PROJECT : BW2
Quanta Computer Inc.

Revision	Date	Phase	Change List	Release Schematic Date	Release Gerber File Date
1A	07/08 2005	DV	Initial release		
2A	08/31 2005	SIV	See page 77 Record A-1 (EC A00 - EC A50) See page 78 Record A-2 (EC A51 - EC A92)		
3A	11/22 2005	SIT	See page 79 Record B-1 (EC B01 - EC B44)	2005/12/15	2005/12/15
3B	02/14 2006	SVT	See page 80 Record C-1 (EC C01 - EC C12)	2006/02/17	2006/02/23

PROJECT : BW2	
		Quanta Computer Inc.	
Size Custom	Document Number	EC RECORD A-1	
Date:	Thursday, March 02, 2006	Sheet	77 of 79
		Rev	3B

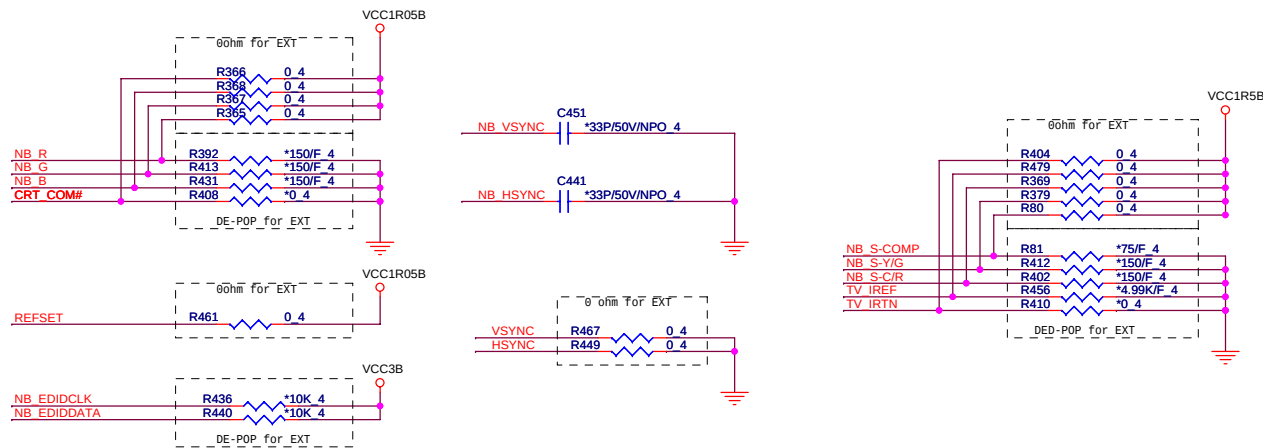
EC A01

EC A01/10/Add R805, R806, R807 for 945GM by VCC1R5B, VCC2R5B and 0 ohm change to ASM.

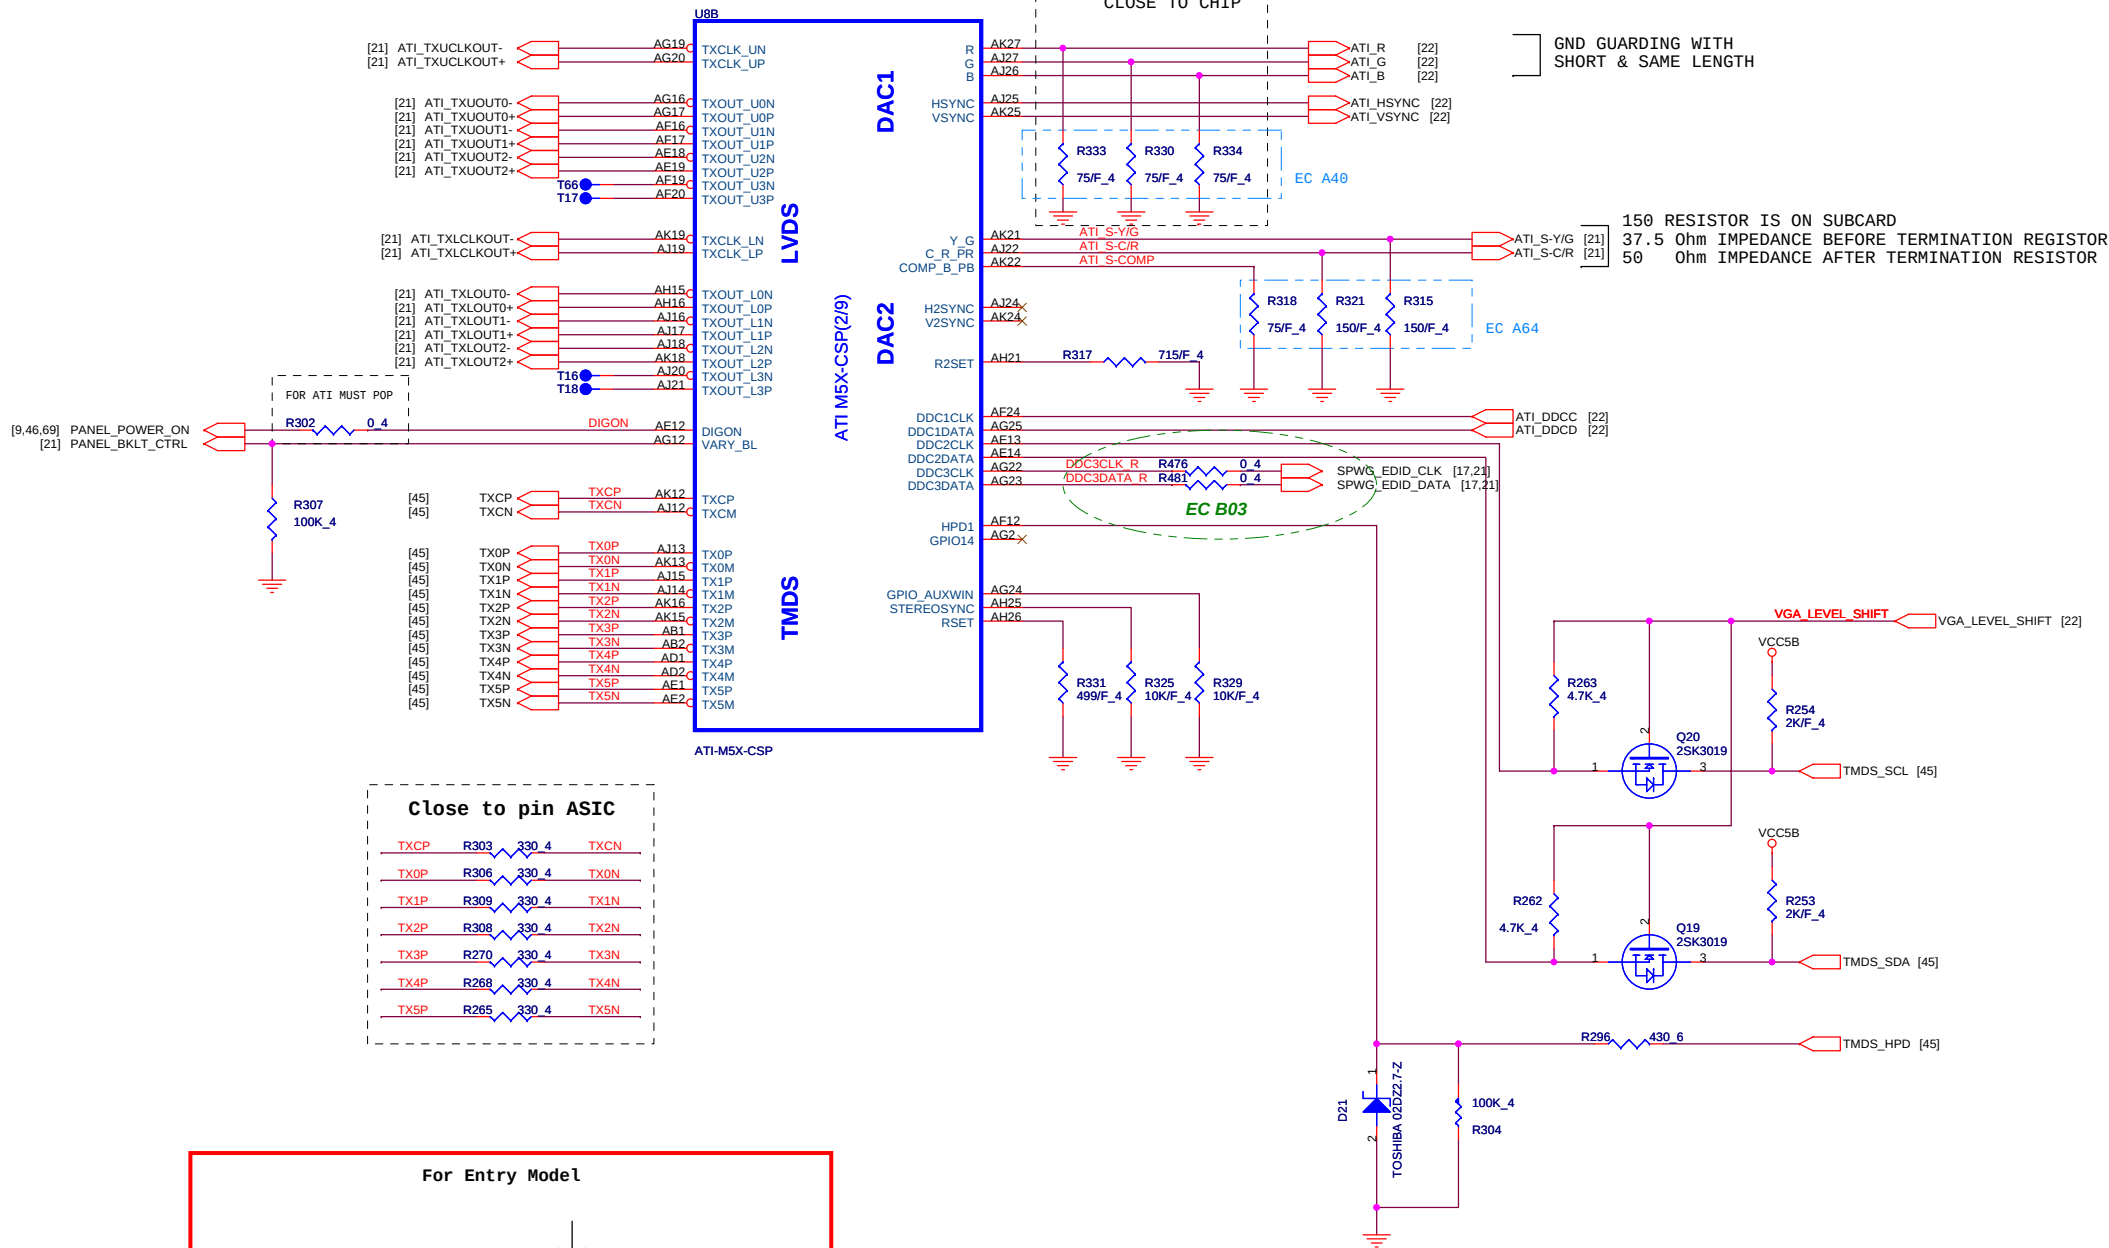
EC B33

- EC B33/17 Add crystal oscilator circuit. (SIT-LENOVO-036)
- EC B34/50 Add FUSE for USB hub sub card. (SIT-LENOVO-035)
- EC B35/67 Change VCCVIDEOCORE voltage. (SIT-LENOVO-034)

CRT PORT

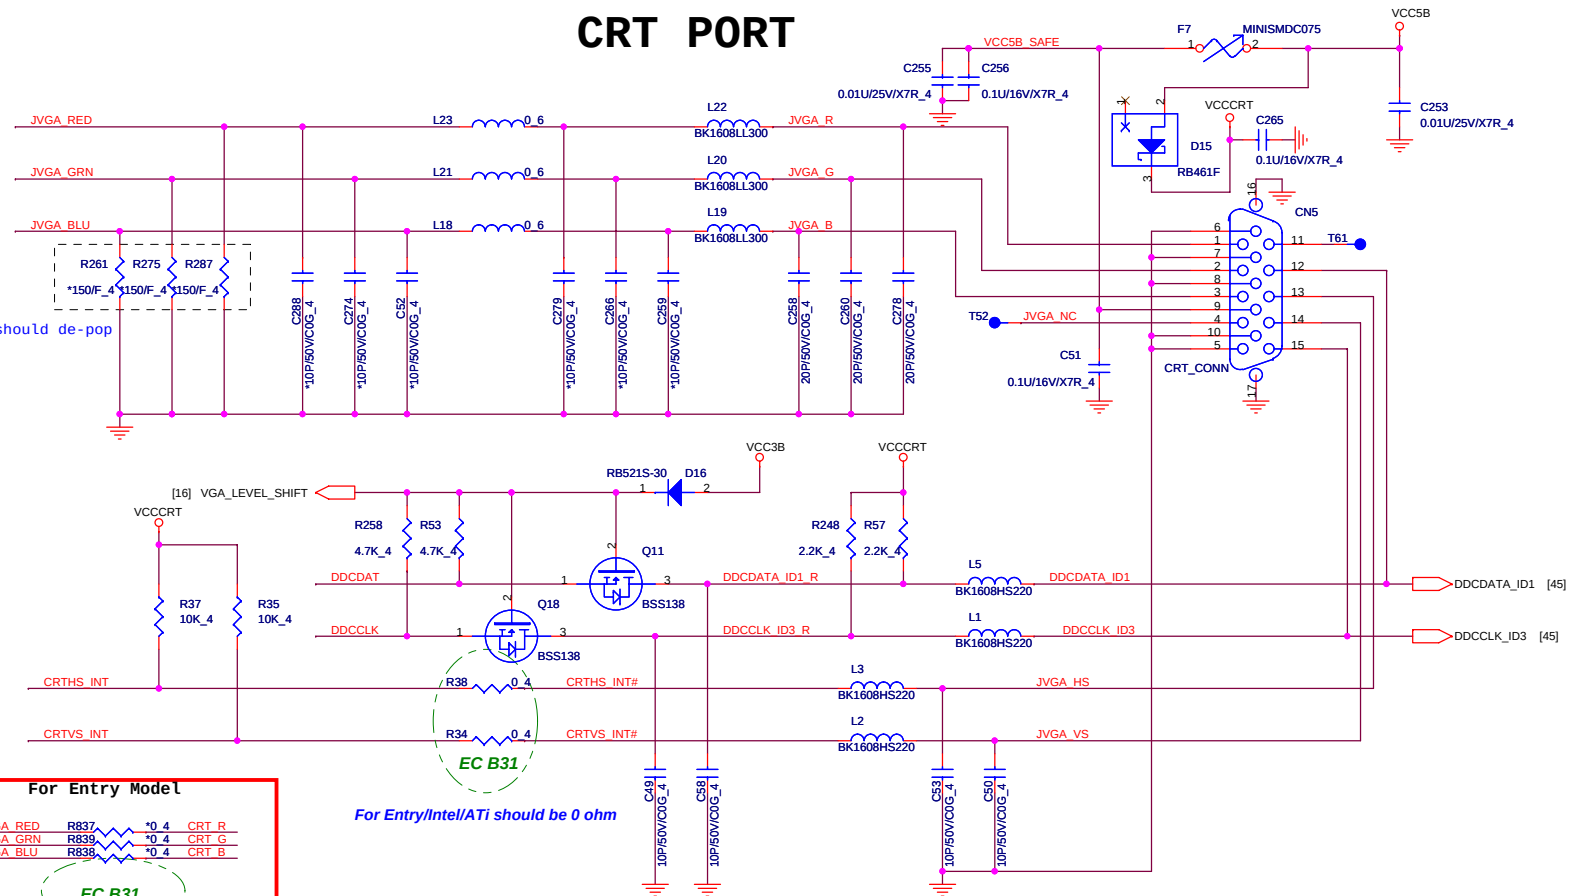
EC A03

EC B31

EC A03/22/D7, D8, D9 ,D18 DA204U change to ASM for CRT ESD .

- EC B30/31/32 Modify audio jack sense circuit.
- EC B31/22 Modify CRT circuit for Entry/Intel/ATi model. (SIT-LENOVO-033)
- EC B32/21 Add ESD cap for stereo Mic signals. (SIT-LENOVO-037)

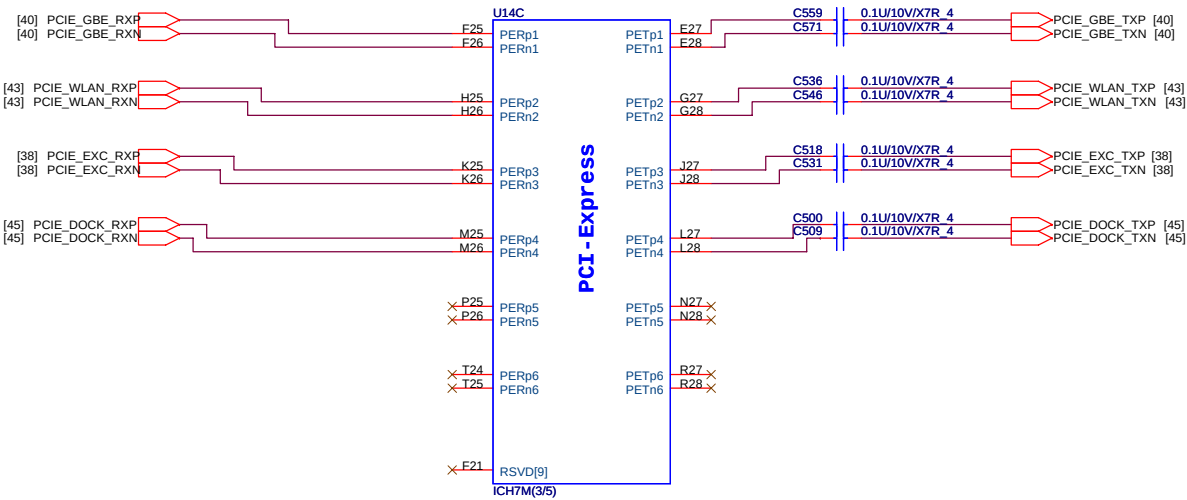
EC A30

EC A30/25,26/Delete R481, R482, R545, R546, R476, R490 and 0 ohm change to NO_ASM for removing 0 ohm jumper from SIV-Lenovo-012.

MINI PCIE CONN-1 FOR WWAN

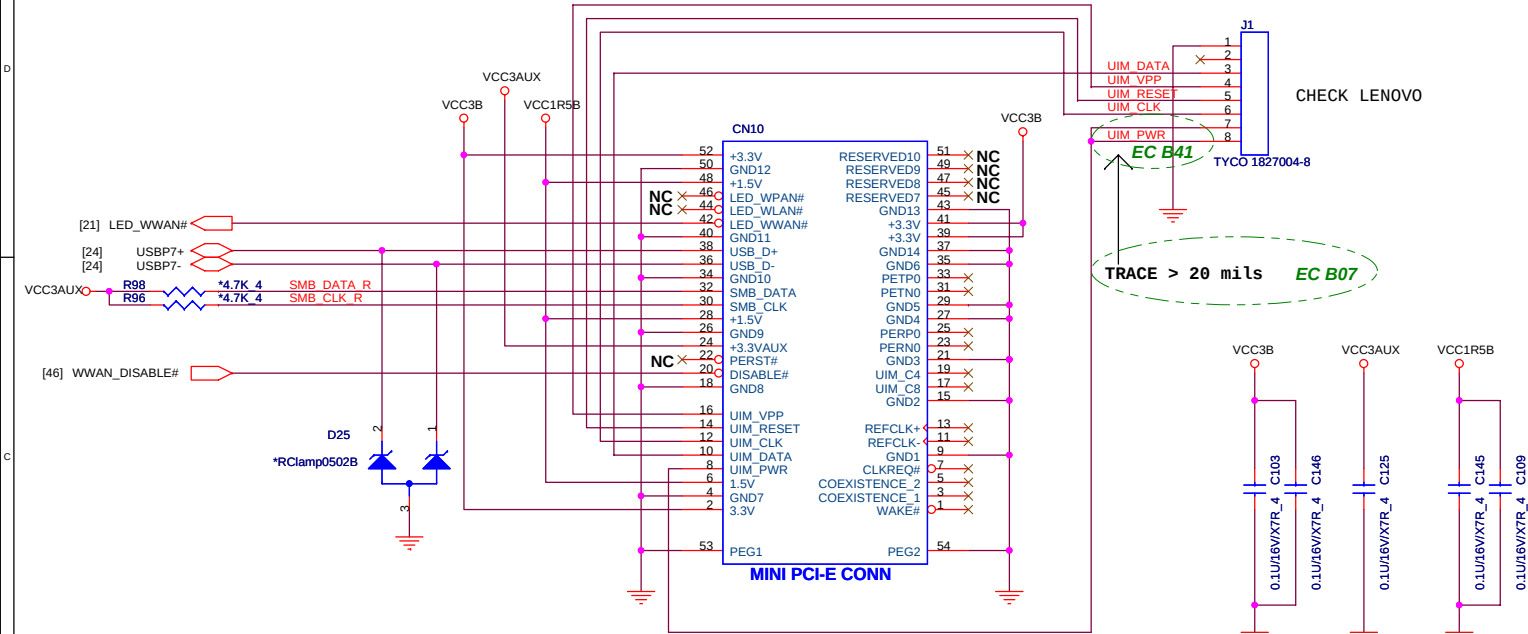
EC A32

EC A32/43/J1, CN10 change to NO_ASM for Non-WWAN model from SIV-Lenovo-014.

8Mbit (1M Byte), SPI

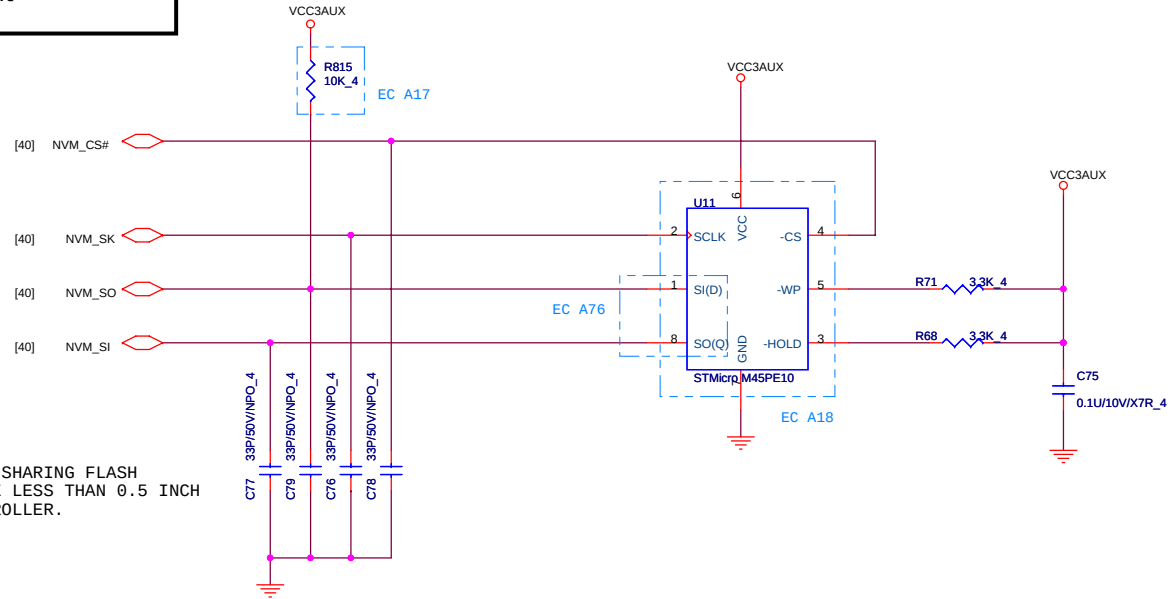
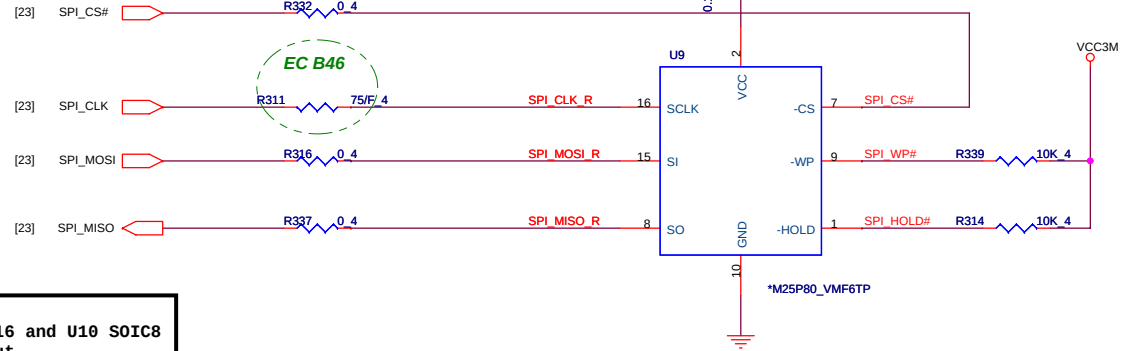
EC A89

EC A87/60/PR176 2K/F ohm change to ASM for Entry Model from SIV-Lenovo-044.
EC A88/65,66,67/PL2, PL16, PL17, PL18 from Bead change to 0 ohm.
EC A89/44/U10 from ST M25P80 change to Mocronix MX25L1605A.
EC A90/09/R465 from 100K ohm NO_ASM change to 10K ohm NO_ASM.
~~EC A91/67/PR21 from 82.5K/F ohm change to 100K/F ohm, PR24 from 17.8K/F ohm change to 0 ohm for M52 and from 40.2K/F ohm change to 22.1K/F ohm for M54/M56.~~
EC A92/62/PR265 from 36.5K/F ohm change to 43K/F ohm.
EC A93/67/PR21 from 100K/F ohm change to 90.9K/F ohm for M52/M54/M56, PR24 from 0 ohm change to 9.09K/F ohm for M52 and from 22.1K/F ohm change to 31.6K/F ohm for M54/M56.
